**Addendum No. 3**  
Page 1 of 23

**TO:** Prospective Respondents  
**SUBJECT:** Addendum No. 3  
**PROJECT NAME:** Romeoville Campus Expansion Bid Release 2  
**JJC PROJECT NO.:** B15028

This Addendum forms a part of the Bidding and Contract Documents and modifies the original bidding document as posted on the JJC website. Acknowledge receipt of this addendum in the space provided on the Bid Form. FAILURE TO DO SO MAY SUBJECT BIDDER TO DISQUALIFICATION.

M222.01

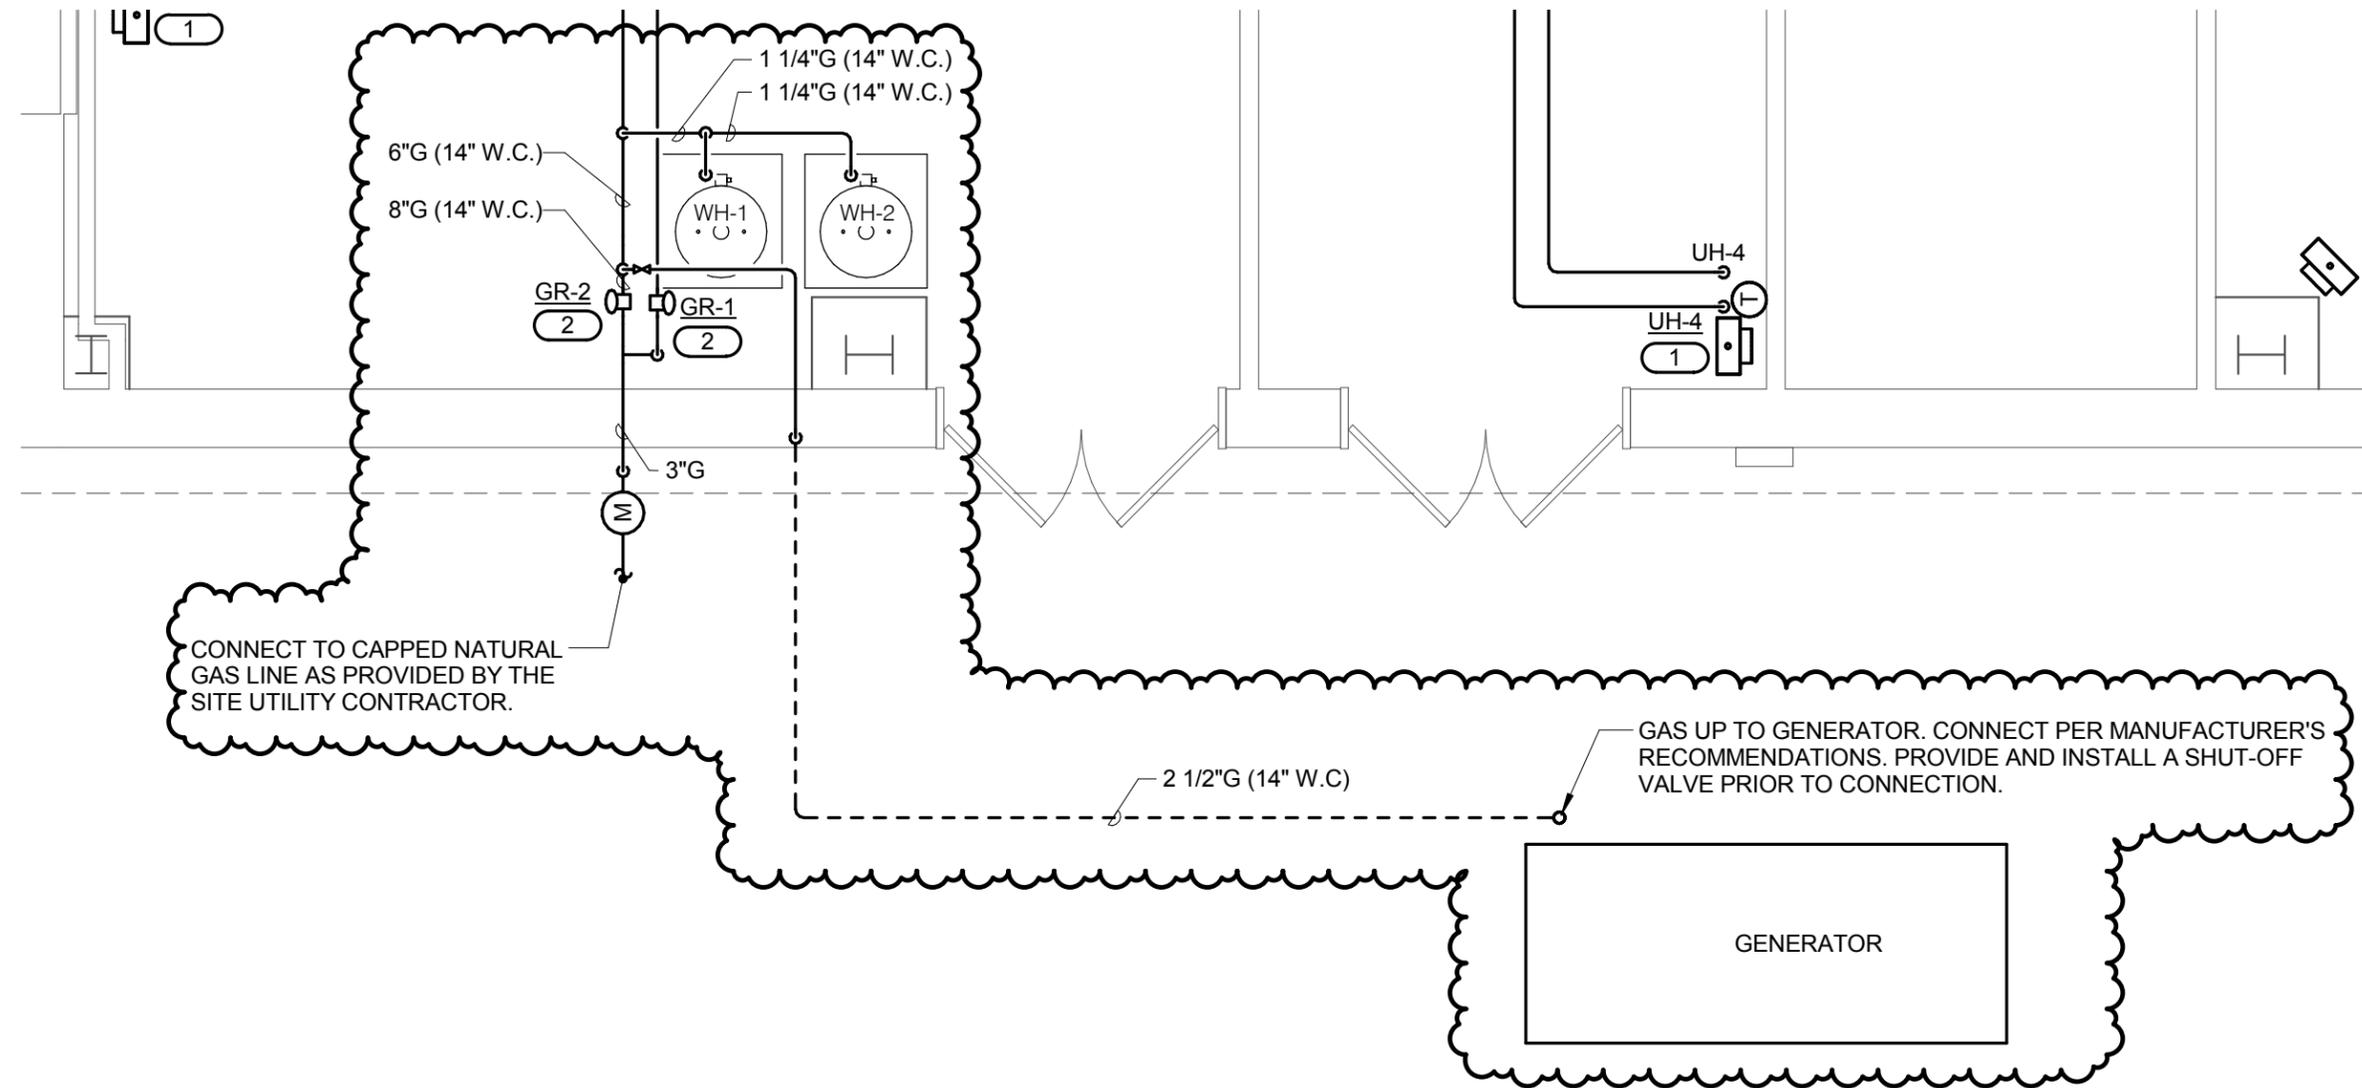
- 1) **ADD** general note to sheet as follows: "CONTRACTOR SHALL PROVIDE AND INSTALL ALL PIPING REQUIRED TO CONNECT TO FUME HOOD FIXTURE INLET/OUTLET INCLUDING PIPING WITHIN FUME HOOD."
- 2) **MODIFY** heating piping and piping accessories associated with TAB-224. Refer to M222.01 for more information.

## CONDENSATE TRAP DETAIL (BLOW-THROUGH)

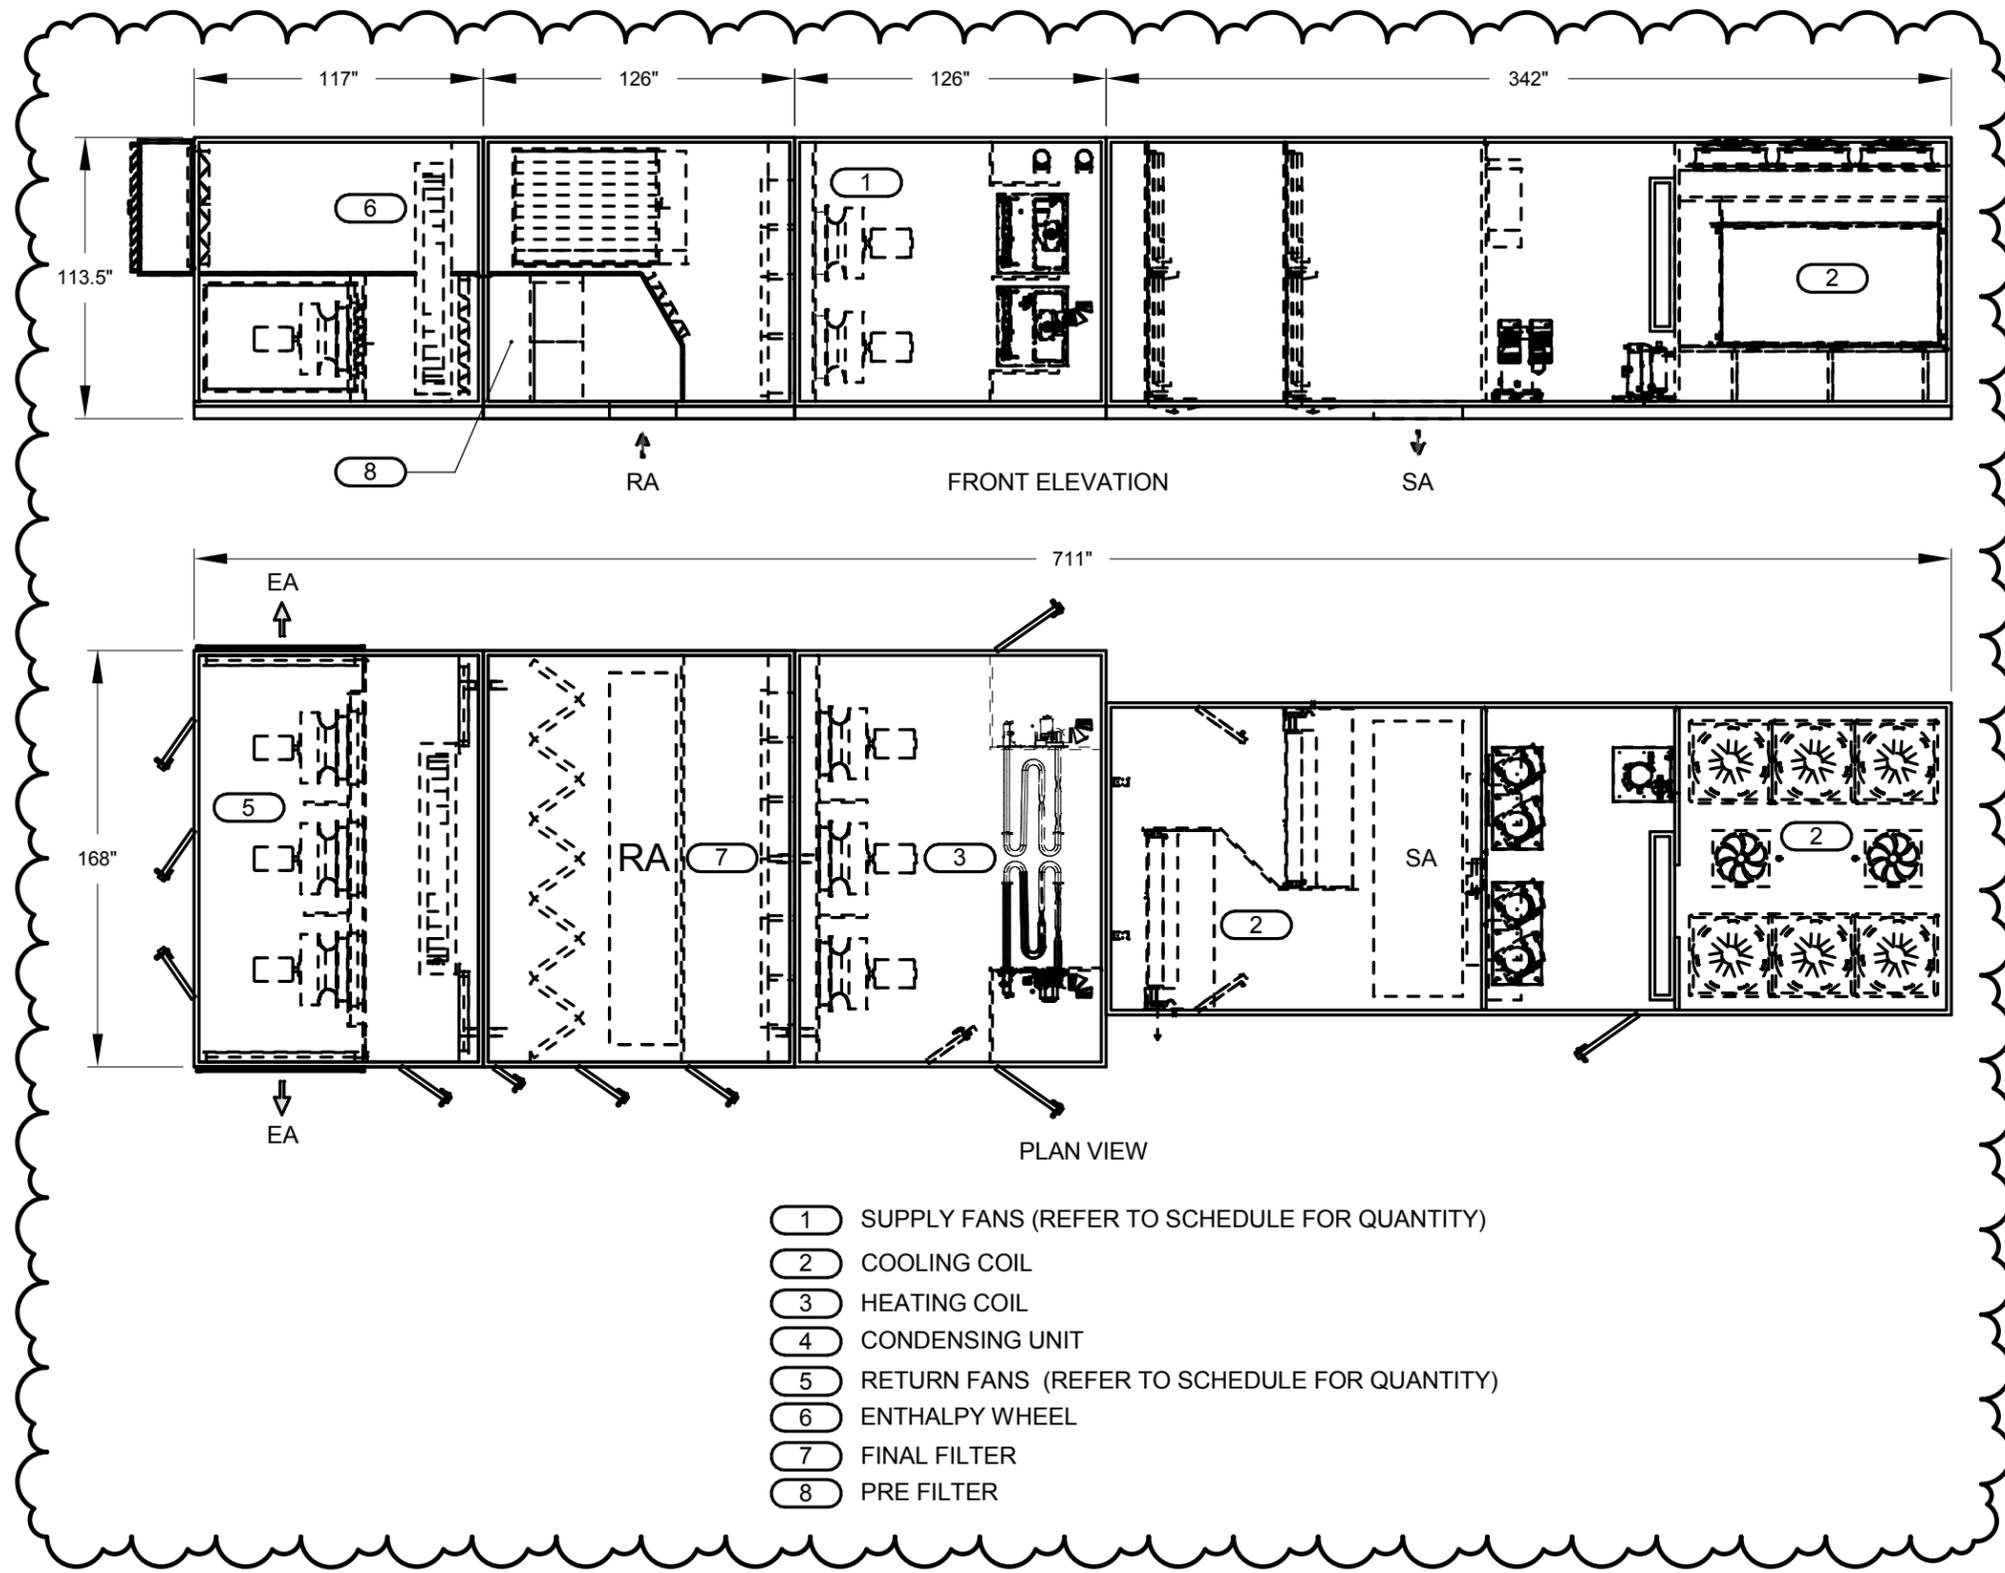
- 1) **ADD** a new Condensate Trap Detail (Blow Through), **MODIFY** Condensate Trap Detail (Draw-Through). Refer to M400.01 for more information.

**7 RTU 3 DETAIL**  
NO SCALE

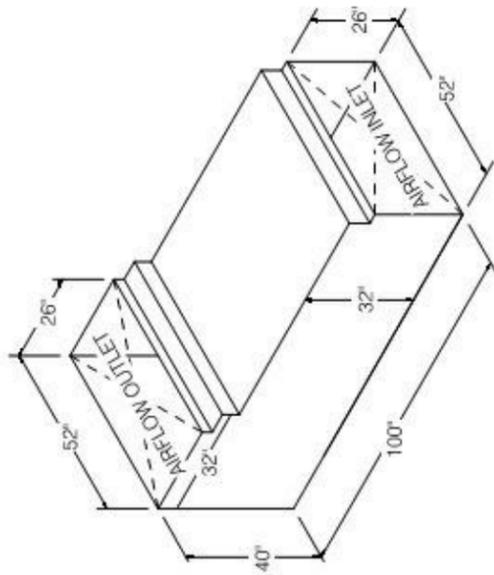
- 1) **ADD** detail for RTU-3. Refer to M402.01 for more information.

P101.01

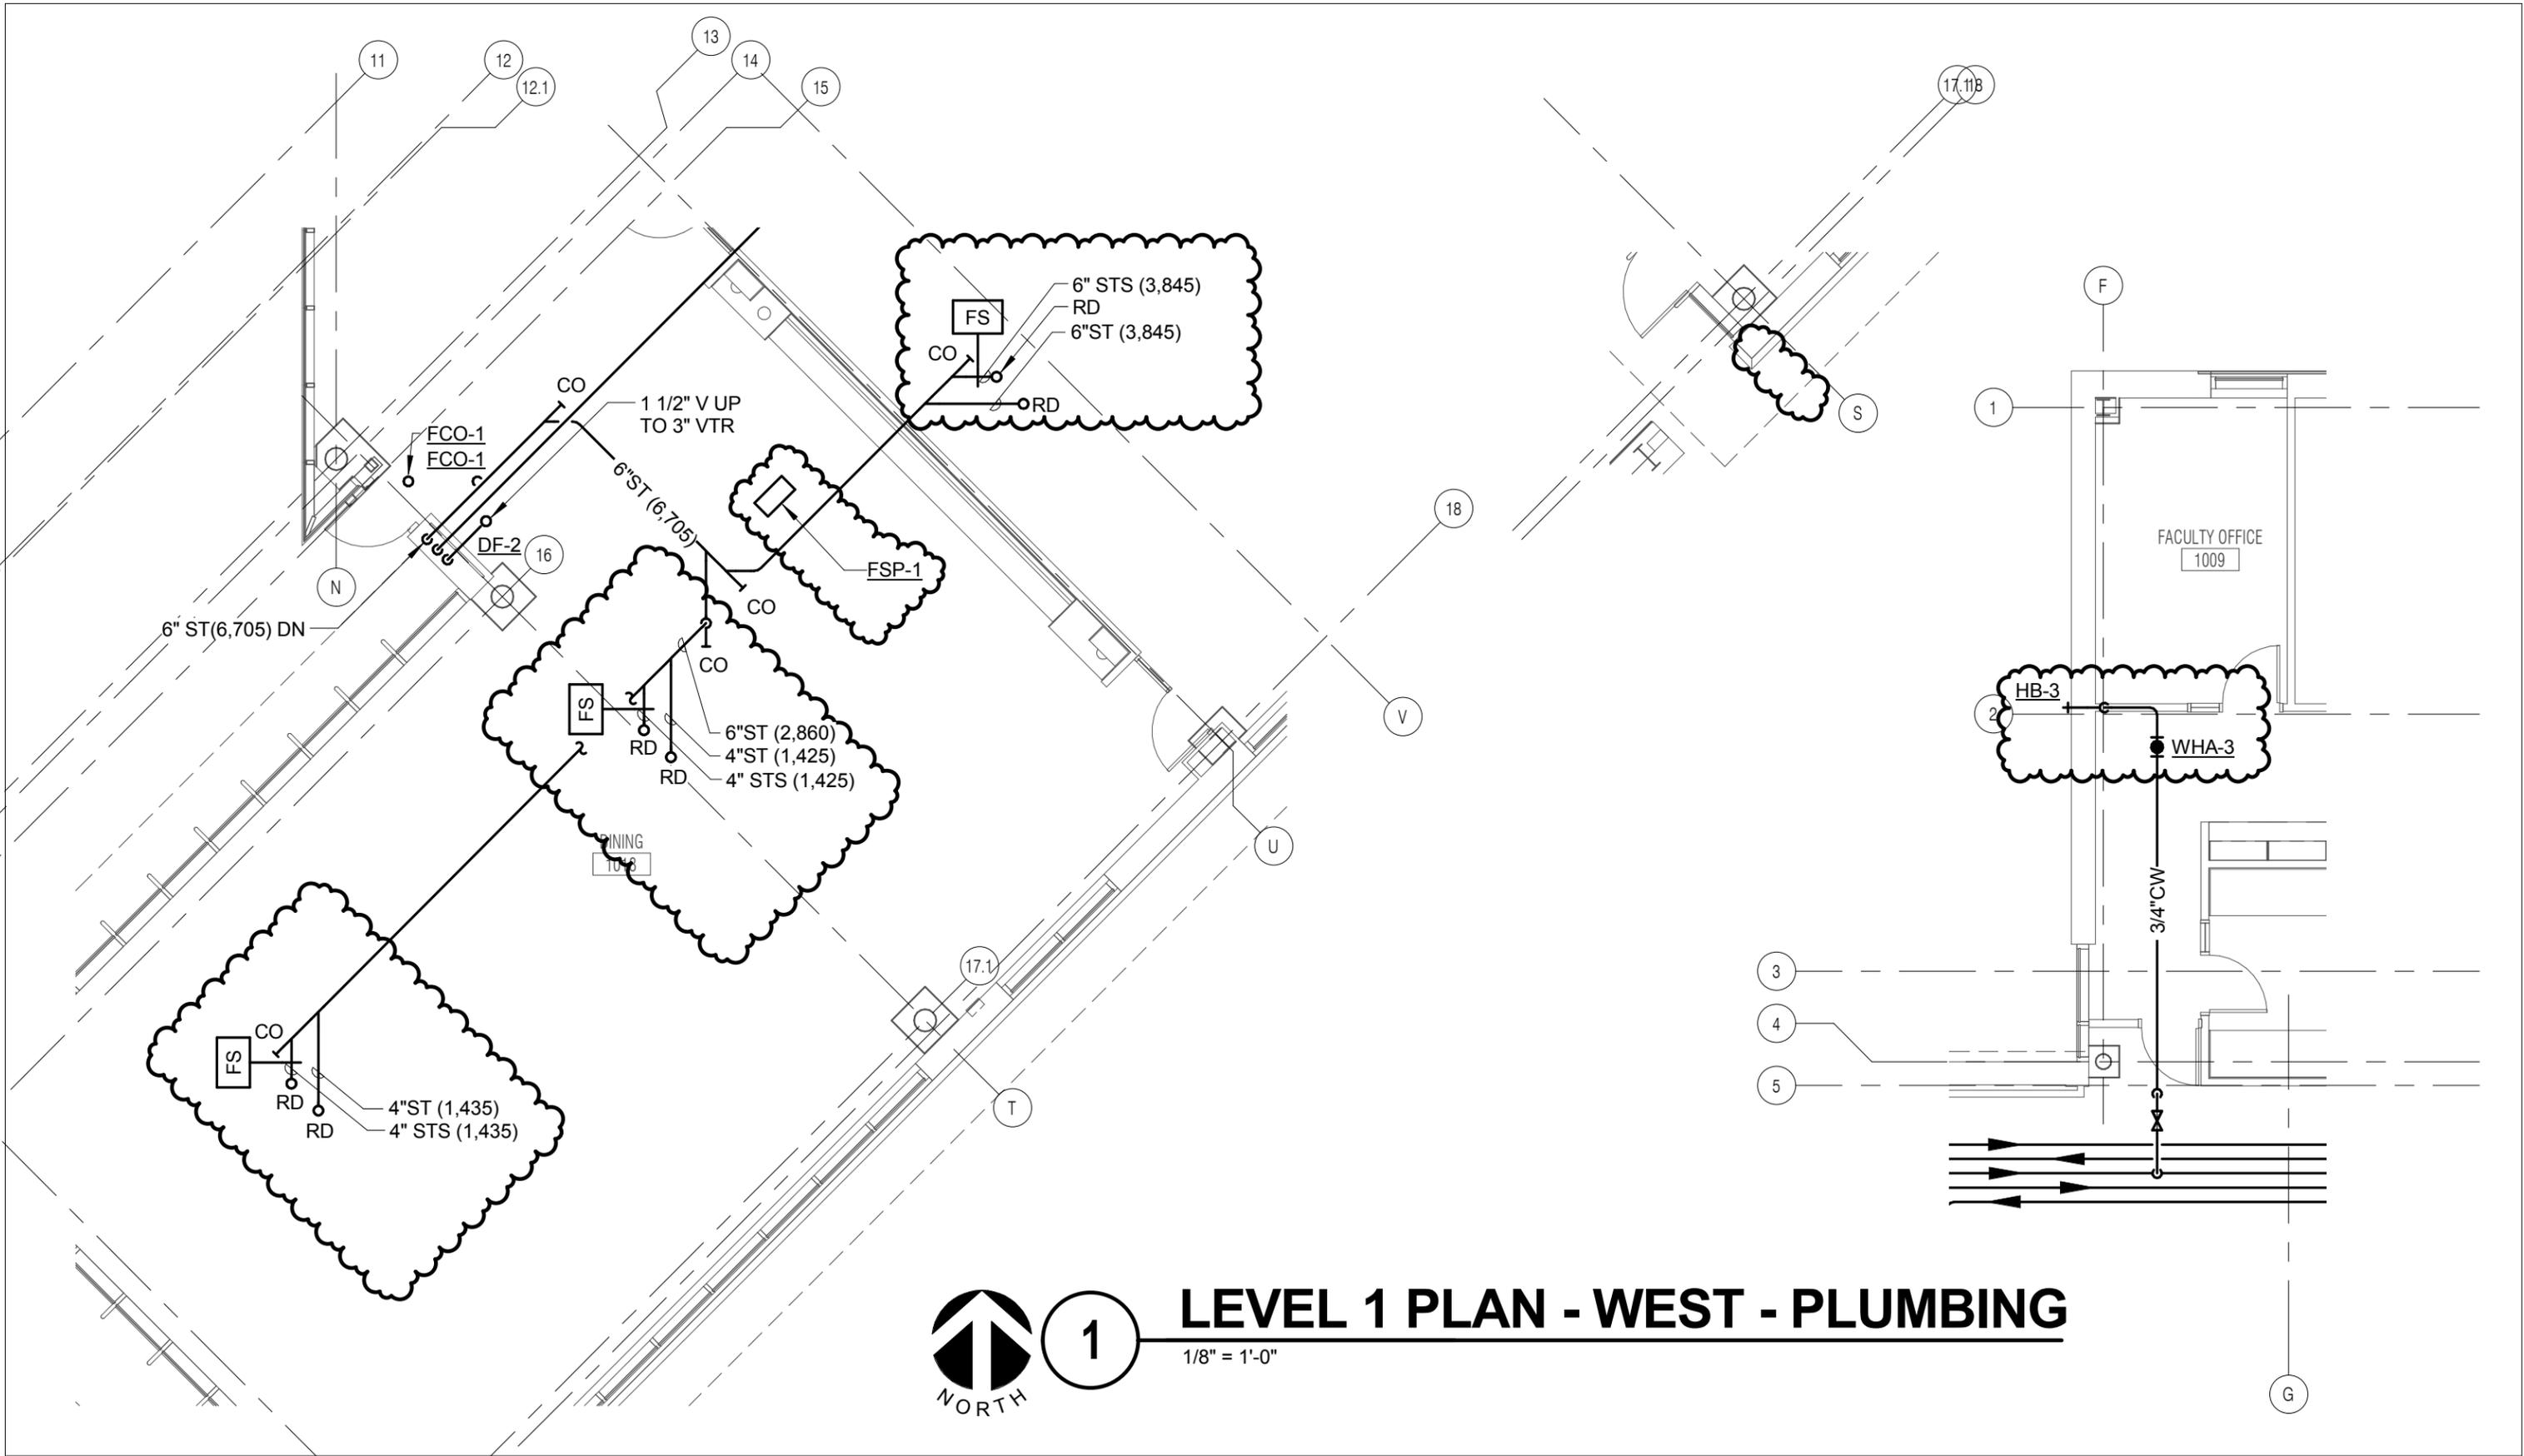
1. **ADD** missing vent piping to floor drains. Refer to sketches P101.01, P302.01 for more information.
- B. Drawings P1.11
1. **MODIFY** location of hose bib located at the exterior wall of Faculty Office 1009. **REMOVE** Hose bib which is located near to column line S & on the exterior wall of Dining 1018. **ADD** flow sensor panel (FSP-1) for secondary roof drain sensor above ceiling of DINING 1018. **SWITCH** primary & secondary roof drain location and **MODIFY** flow sensor location & tags accordingly. Refer to P111.01 for more information.

## P112.01

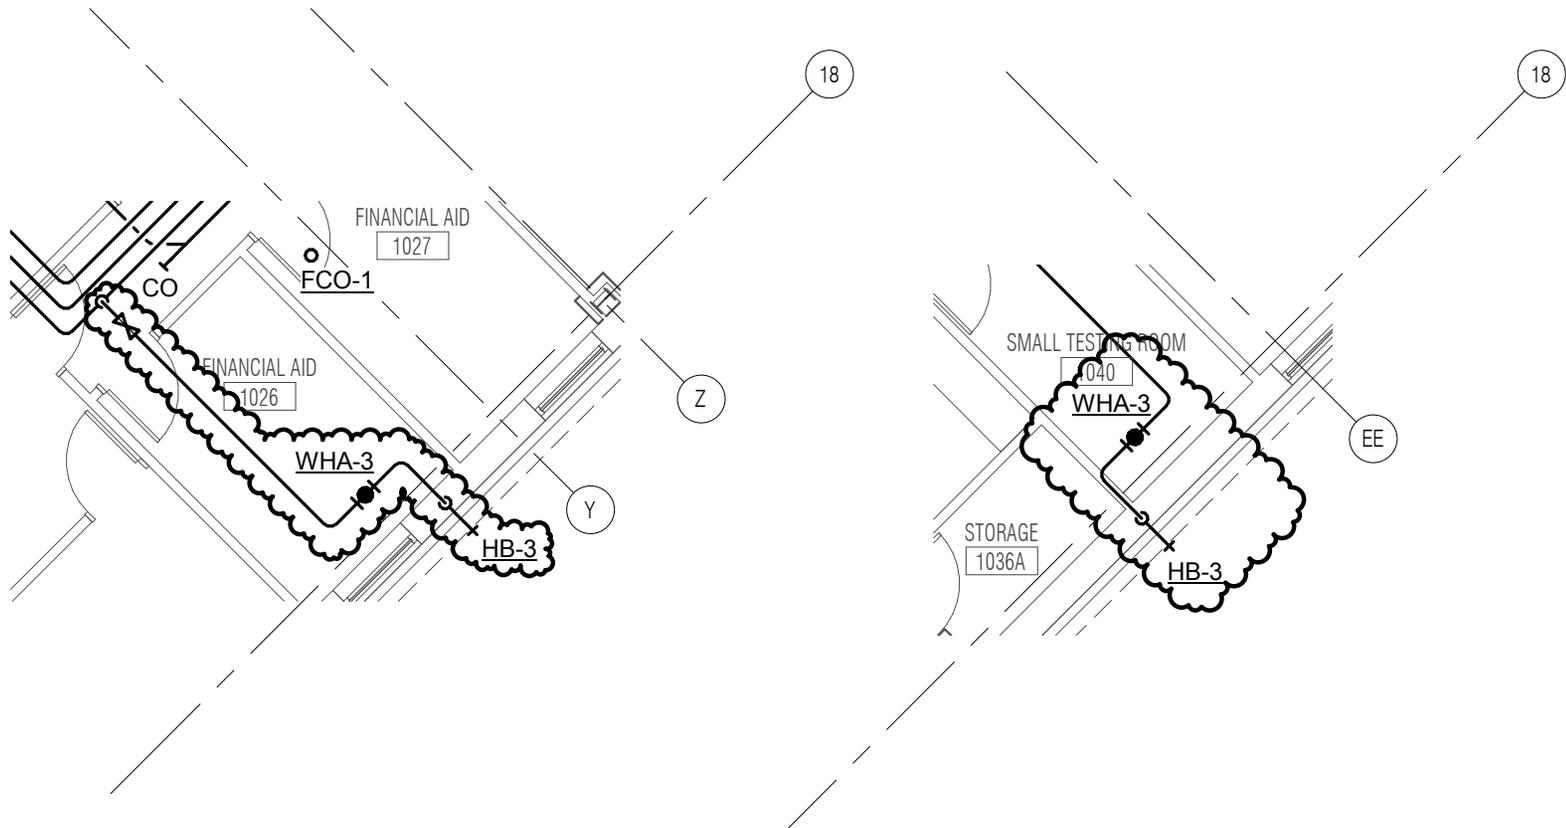
2. **MODIFY** the tag for the hose bibb on the exterior wall of RECEIVING 1015 as follows: "~~HB-1~~ HB-3"
- C. Drawing P1.12
1. **ADD** new flow sensor panel (FSP-1) for secondary roof drain sensor above ceiling of LINK 1120. Refer to P112.01 for more information.
